SITE PLAN ACCESS COMPLIANCE

RENAISSANCE 2 @ LEE MATHSON MIDDLE SCHOOL
SHADE STRUCTURE
2050 KAMMERER AVE., SAN JOSE, CA 95116
ALUM ROCK UNION SCHOOL DISTRICT

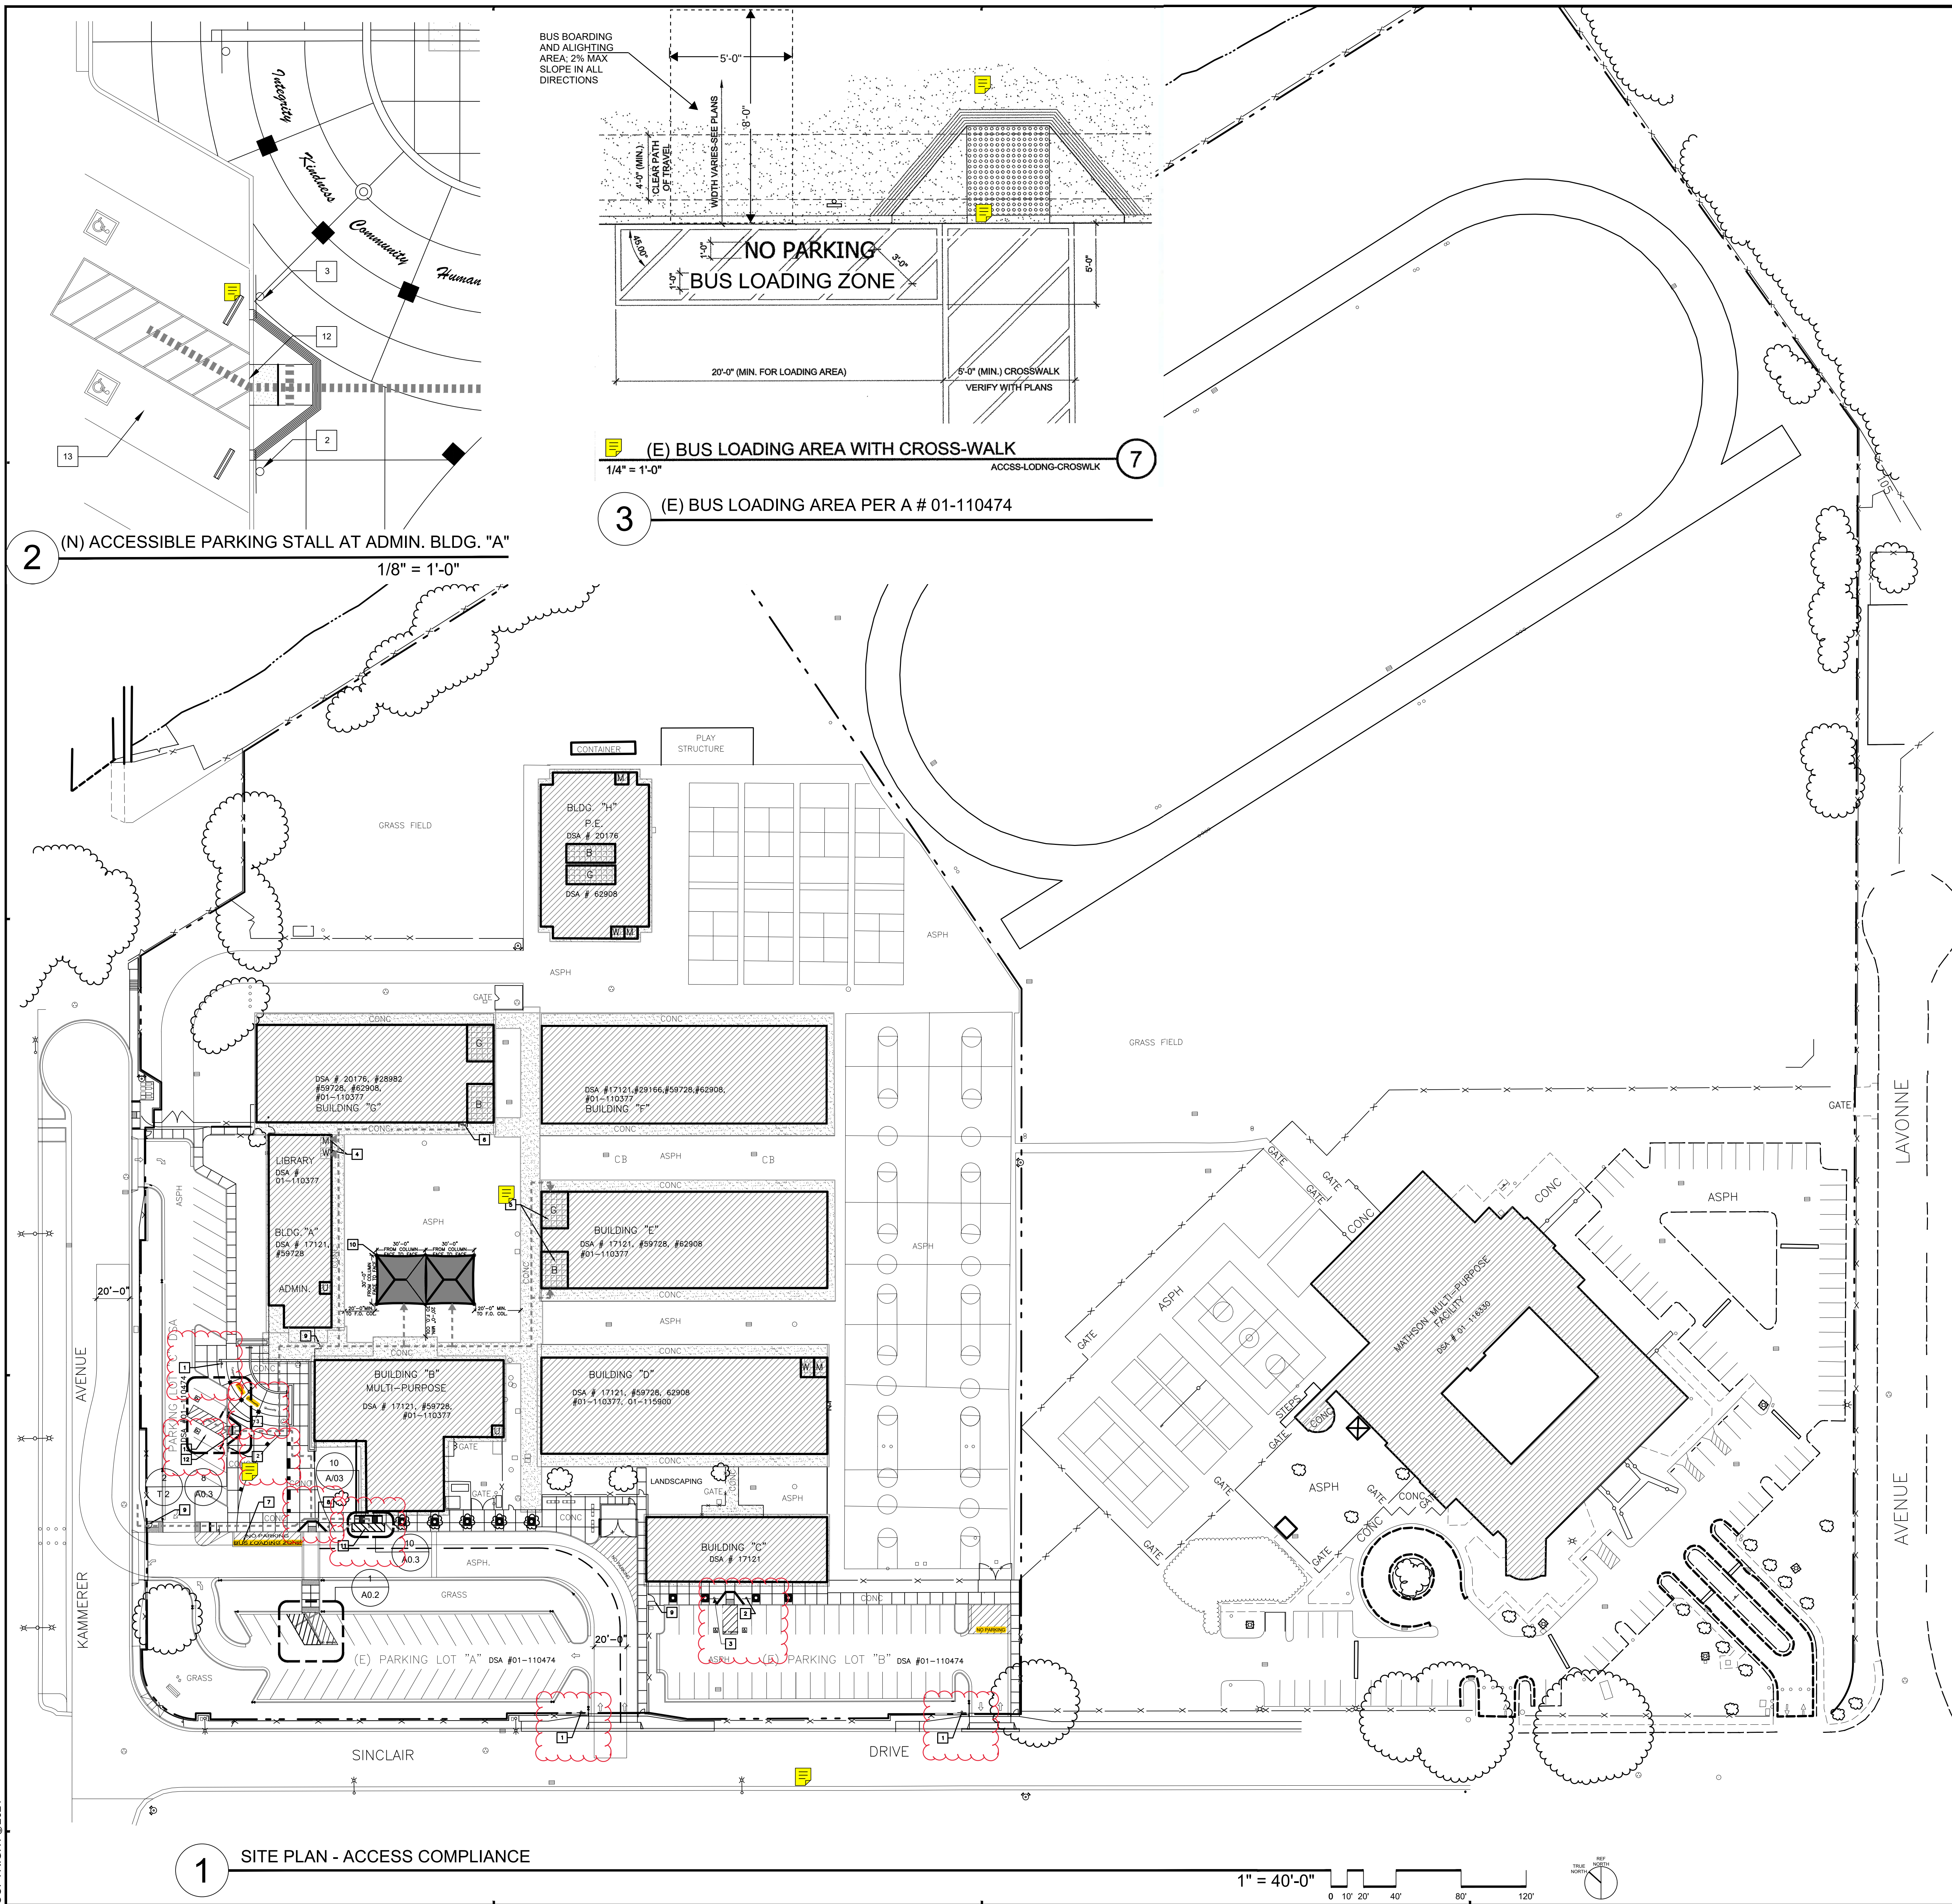
Request DSA inspector to V.I.F if this work is required or (E) conditions are acceptable

Critical impact area(s), may be better to save this work until Spring Break or Summer 2023

01-115742 not certified; this project can't be approved unless 01-115742 is certified

SITE PLAN
FIRE LIFE SAFETY

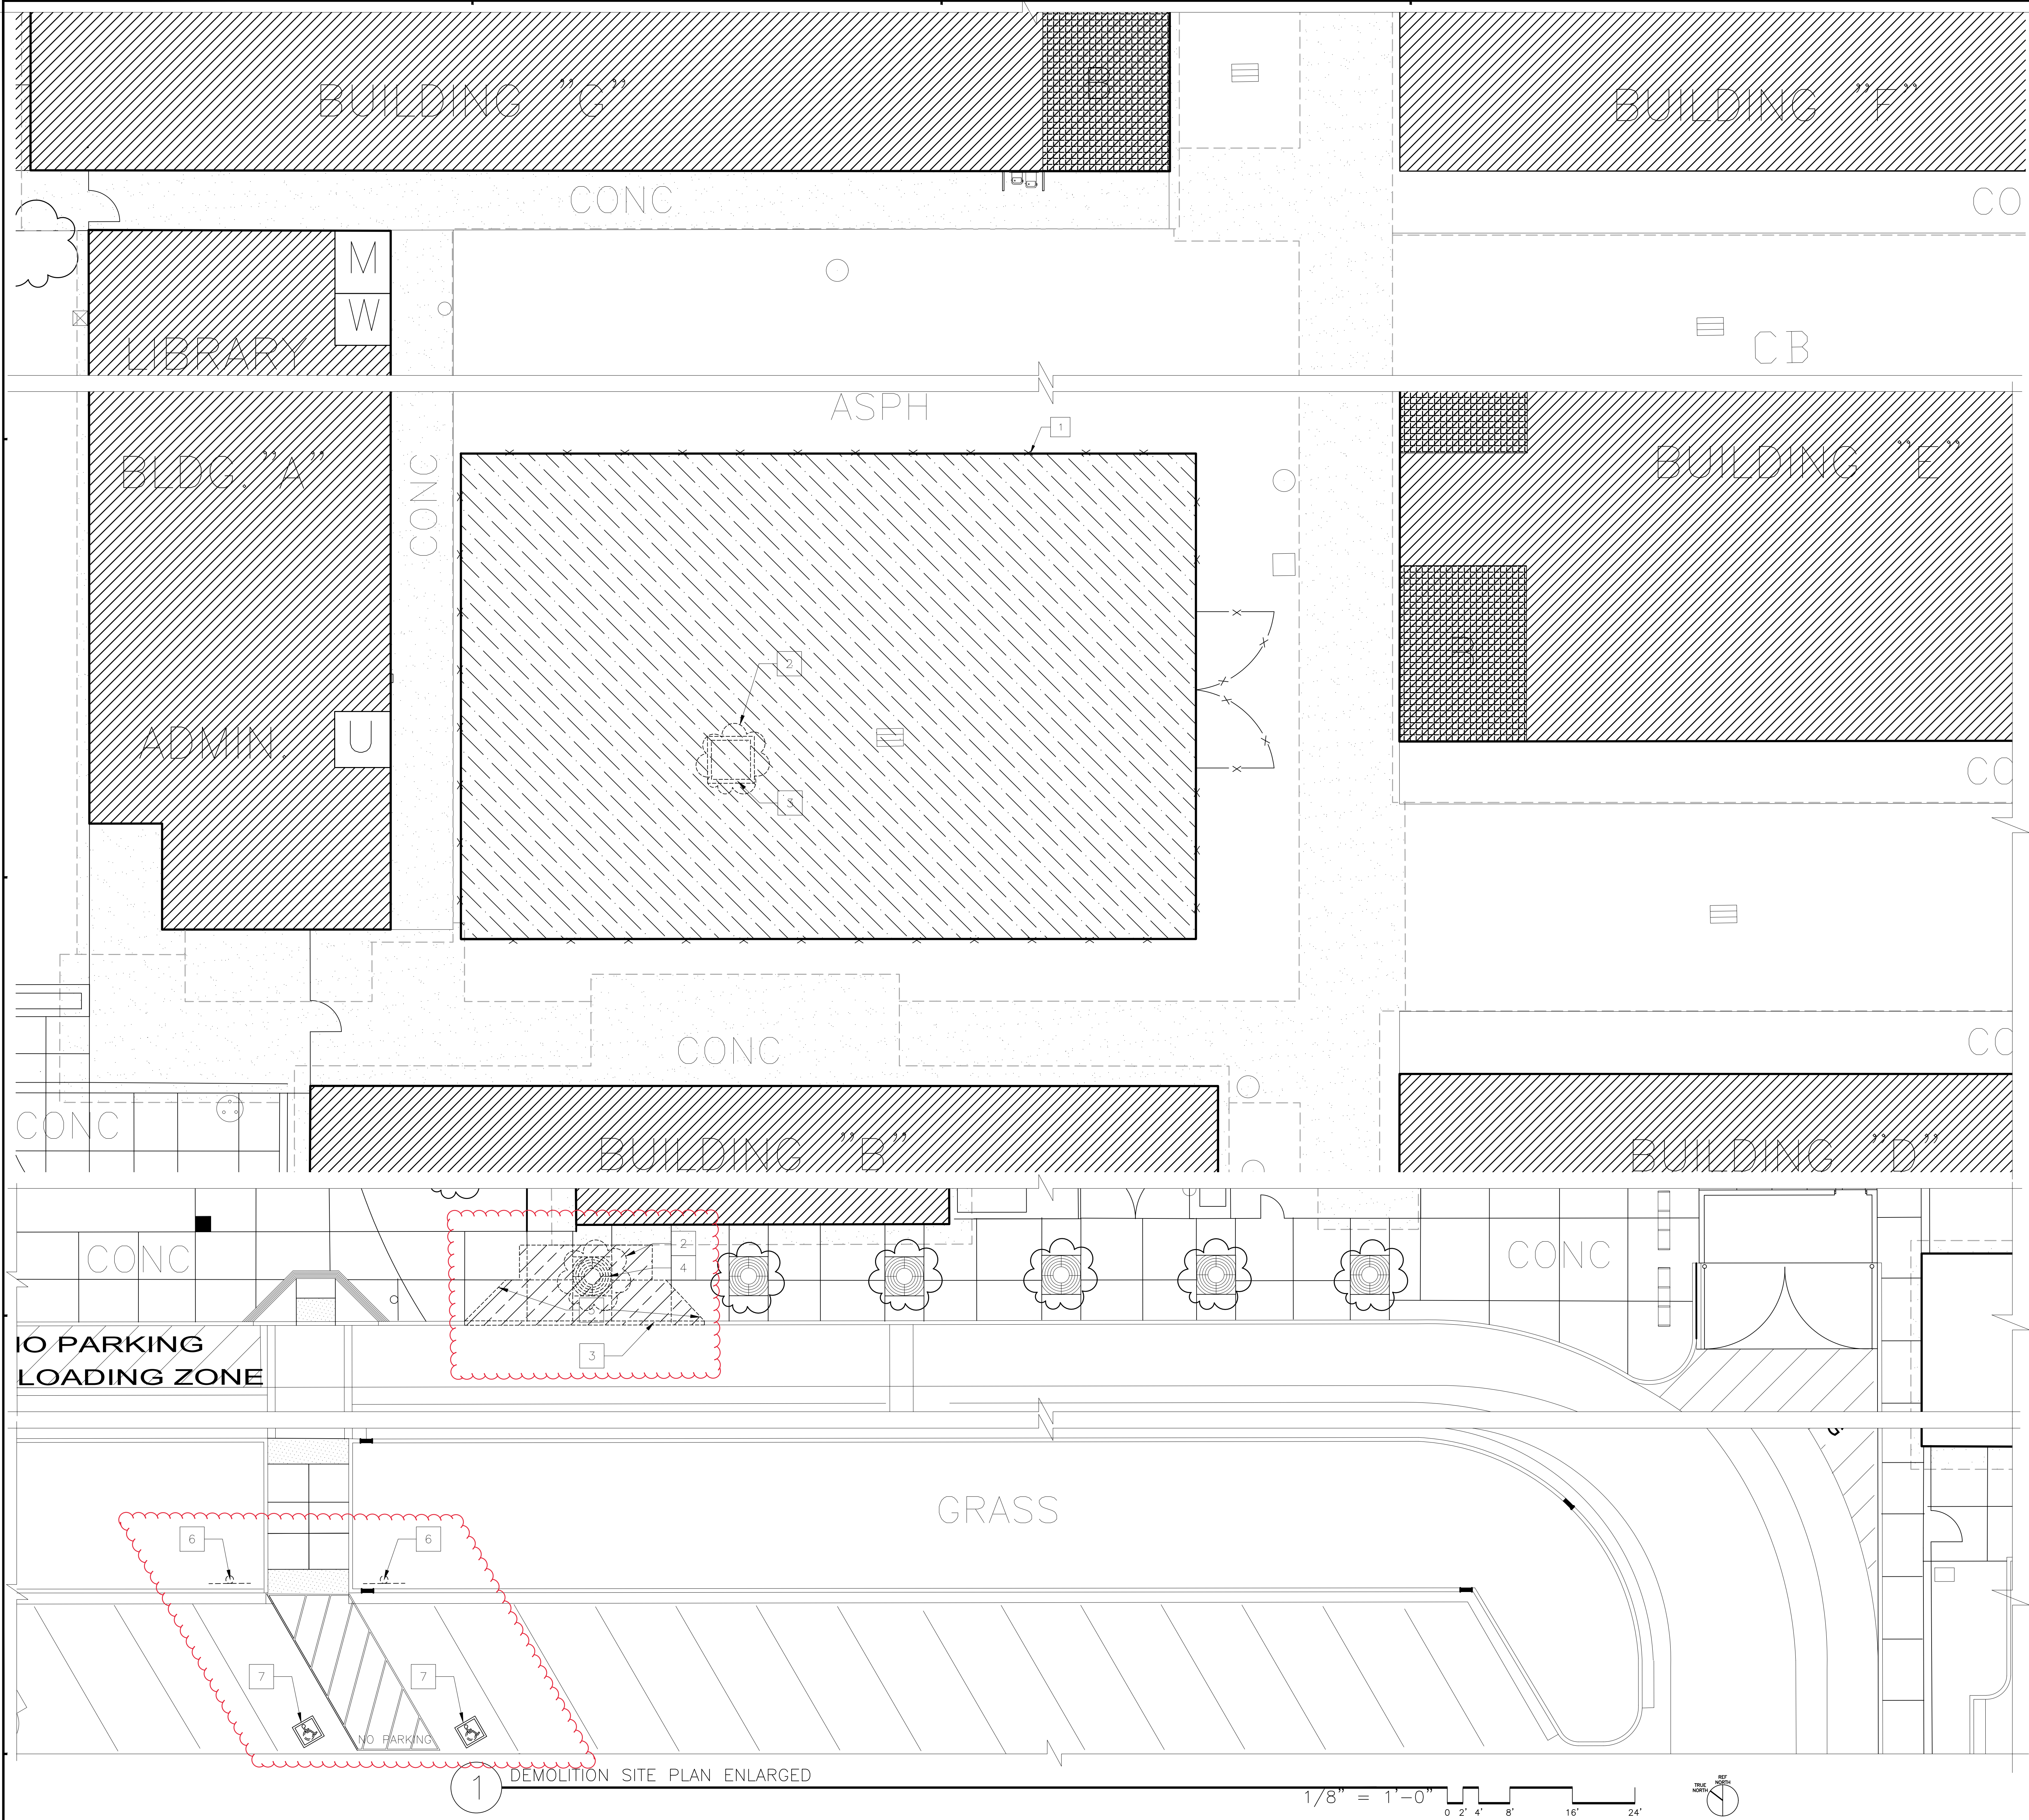
COPIED FROM TITLE PAGE. SAN JOSE LOCAL FIRE REQUESTED THIS BE ADDED SO THEY HAVE A
RECORD OF THE PROJECT SCOPE.
